IREDELL COUNTY HEALTH DEPARTMENT

IMPROVEMENT PERMIT / AUTHORIZATION TO CONSTRUCT / OPERATION PERMIT / EXISTING SYSTEM INSPECTION

PERMIT# 117704 PIN# 4629-78-2986 ROGER WAY, JR DATE 2-12-04

SUBDIVISION CRESCENT LANDING BLOCK / SECTION ____ LOT 801 LOT AREA .81AC SITE CLASS. IV DESIGN FLOW 360 L.T.A.R. .3

INITIAL SITE SKETCH 1" = 50'

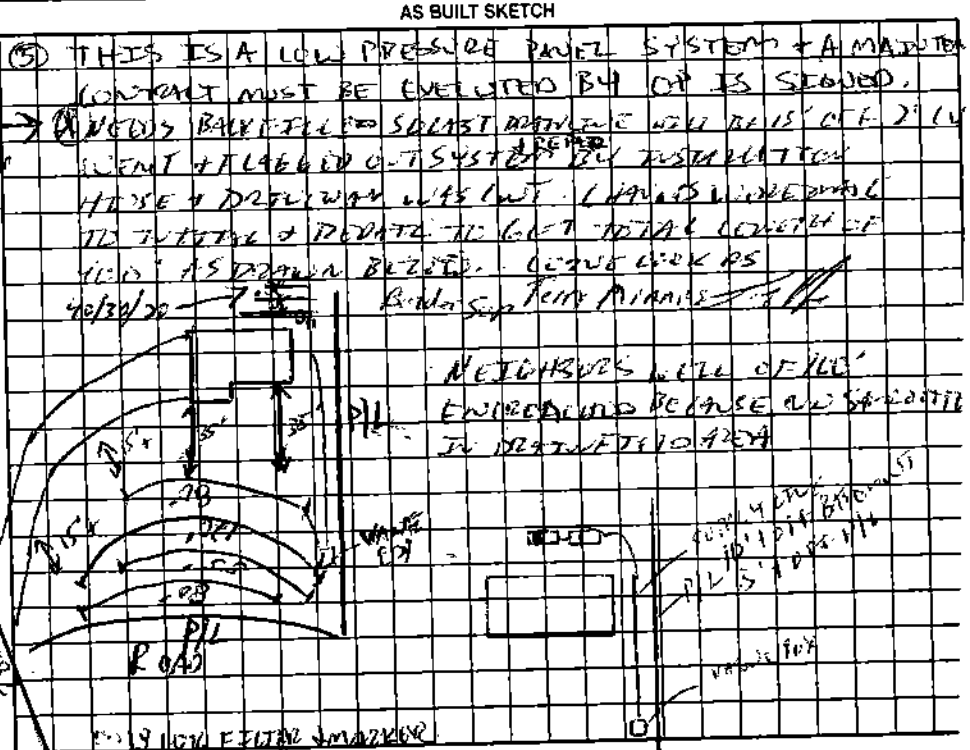
Comments:/Conditions: (1) SYSTEM & HOUSE ARE ENTIRELY ELEVATED OUT ON LOT (2) DRIVEWAY MUST NOT BE CUT. IT MUST REMAIN AT NATURAL GRADE OR THE REPAIR WILL NOT BE VALID. (3) SUPPLY LINE CROSSING UNDER THE DRIVE MUST

Comments:/Conditions: BE DONE IN ACCORDANCE OF RULE 1950(C)(E). (4) DO NOT CUT LOT FOR POSITIVE DRAINAGE REQMTS. KEEP HOUSE OUT OF THE GROUND & BACK FILL FOR POS. DRAINAGE. THIS CHANGES THE CUTSETBACK OF 35' TO 15" FOR FILLING IT

(5) THIS IS A LOW PRESSURE PANEL SYSTEM & A MAINTENANCE CONTRACT MUST BE ENTERED BY OWNER AS REQUIRED. (6) NEEDS BACKFILL TO SLIGHT GRADE WITH AT LEAST 15" OF 2" CLEAN #1 OVER ENTIRE SYSTEM BY INSTALLATION. HOUSE & DRIVEWAY WAS NOT CUT AS REQUIRED TO INSURE A POSITIVE DRAINAGE AWAY FROM HOUSE & DRIVE. DO NOT CUT MORE THAN 6" OF EXISTING GRADE. CURVE LOOK AS SHOWN BELOW. 10/30/20 Brenda Sipe Rem Manager
